TOWN OF EAST HAMPTON

Planning Department Marguerite Wolffsohn Director

SITE PLAN INITIAL EVALUATION Bostwick's Chowder House Walk-In Cooler - Site Plan SCTM#300-188-1-18

Northwest corner of the subject property

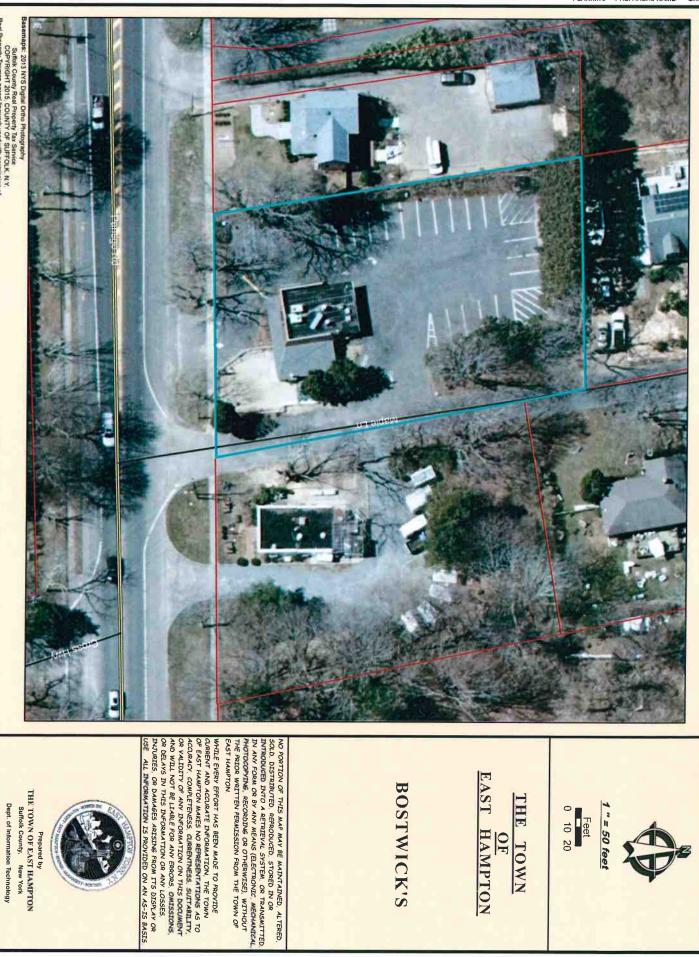
A site inspection on April 7, 2016 reveals that there are numerous accessory structures scattered around the property, particularly in the area near the rear of the principal building and along the northern property line, which borders a residence (see photographs). These include multiple storage bins and a trailer. If these structures are proposed as part of the subject site plan then they should be added to a revised site plan at this time or removed from the property.
